# Sanitize Device Command

May ~~11~~13, 2009

Revision ~~6~~7

6	May 11, 2009	Extensive clarifications from Plenary (including state machine change to add additional completion states and explicitly call out hardware reset)
<u>7</u>	<u>May 13, 2009</u>	<a href="#">Editorial changes and State Machine label changes from May 13<sup>th</sup> Telecon</a>

Figure xx – SANITIZE DEVICE State Machine

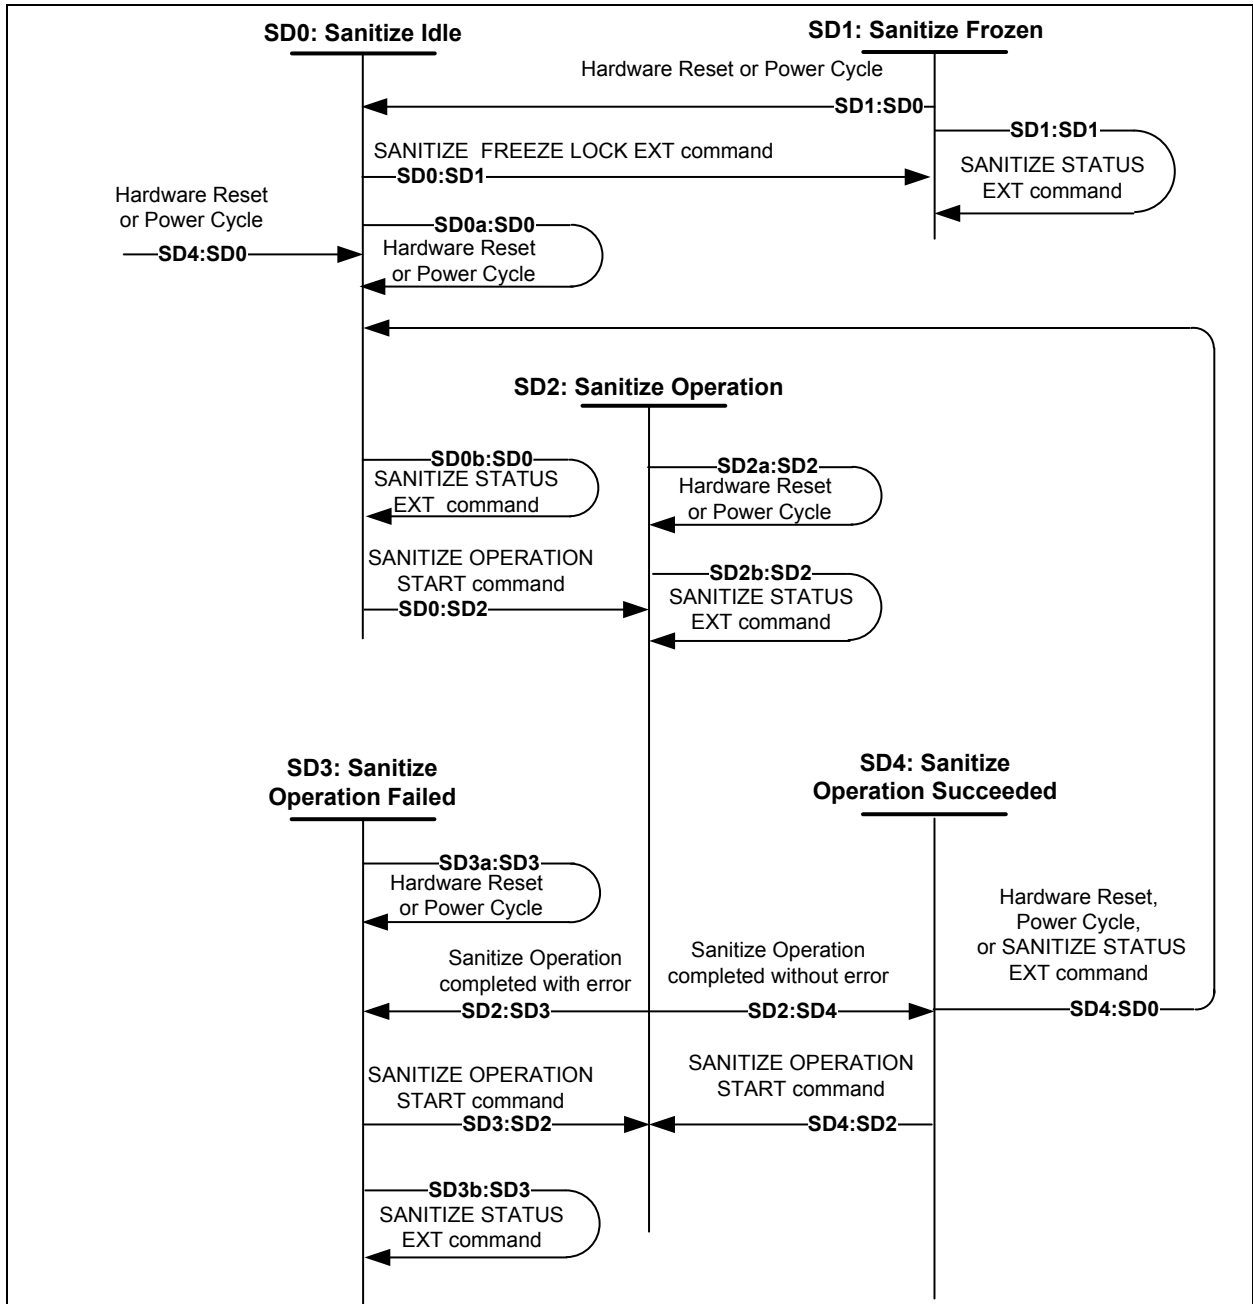
**SD0: Sanitize Idle State:** This state is entered when the device ~~executes a power cycle~~processes a power-on reset from SD0, SD1 or SD4.

**Transition SD0a:SD0:** When the device is in the Sanitize Idle state and it receives a hardware reset or power-on reset, the device shall remain in the SD0 Sanitize Idle state.

**Transition SD1:SD0:** When the device is in the Sanitize Frozen state and it receives a hardware reset [or power-on reset](#), the device shall transition to the SD0 Sanitize Idle state.

- a) the device ~~processes a power-on reset~~ ~~executes a power cycle~~ from SD2; ~~;~~ or
- b) the device is in the SD0 Sanitize Idle state and a supported SANITIZE OPERATION START command is received.

**Transition SD2a:SD2:** When the device is in the Sanitize Operation state and it receives a hardware reset [or power-on reset](#), the device shall remain in the SD2 Sanitize Operation state.

- a) the device ~~processes a power-on reset~~ ~~executes a power cycle~~ from SD3; ~~;~~ or
- b) the device is in the SD2 Sanitize Operation state and a Sanitize Operation completes with an error.

**Transition SD3a:SD3:** When the device is in the Sanitize Operation state and it receives a hardware reset [or power-on reset](#), the device shall remain in the SD3 Sanitize Operation state.

- a) a hardware reset;
- a)b) [a power-on reset](#) or
- b)c) a SANITIZE STATUS EXT command
